From: Acenas, Alexander
Sent: Thursday, June 17, 2010 12:44 PM
To: 'Hsieh, W. Andy'
Cc: Rizzoli, Linda; Nelson, Blake; Sandrine Hitchcock; Glass, Danny W.; Huey, Justin
Subject: RE: CAN 5 6; chair rail height?

BUILDINGS 5 & 6 RENOVATIONS

FIRST & SECOND FLOOR
INTERIOR ELEVATIONS

Date: 08/29/08
Scale: AS NOTED
Project Number: 07013
Drawing Number: A8.2

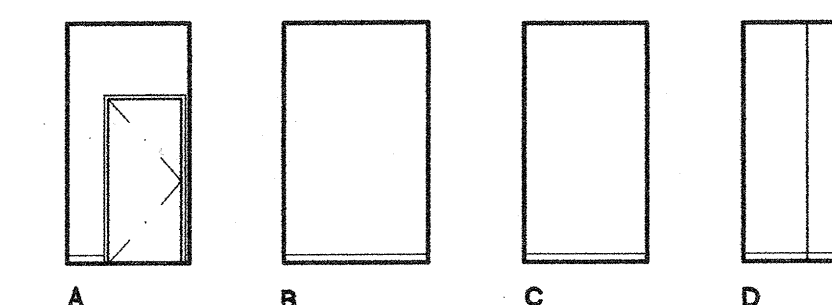
Thanks for setting me up with Phil (and Scott) yesterday afternoon. I got to see a meeting room and a classroom in CSM B5. Based on what I saw, I think the top of the chair rail should be at +36" AFF, +/- 0.5". This will allow the bottoms of tack boards, white boards and marker trays to be at +36" AFF, and also allow the chair rail to run continuously below existing window openings in the exterior concrete wall. Although table edges and chair backs are around 29"-30" AFF, the walls would still be protected by the vinyl wainscot below the chair rail.
